# Squeezer In-vacuum Controls Wiring Chain

VOPO

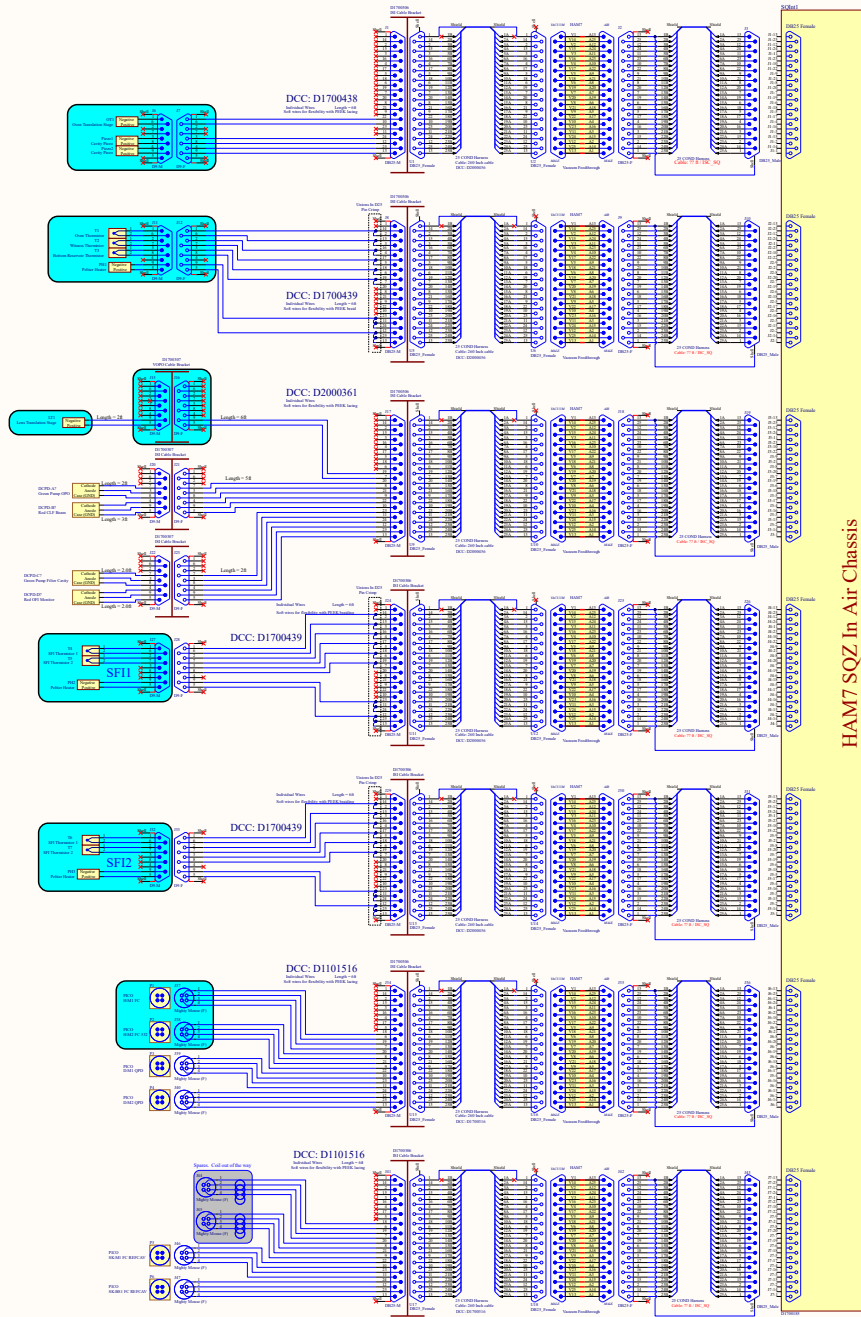
Questions  
 -Confirmation of lengths  
 -In air lengths  
 -First in-vacuum cables are currently 260in  
 -Spider Cable breakout lengths  
 -Feedthrough locations
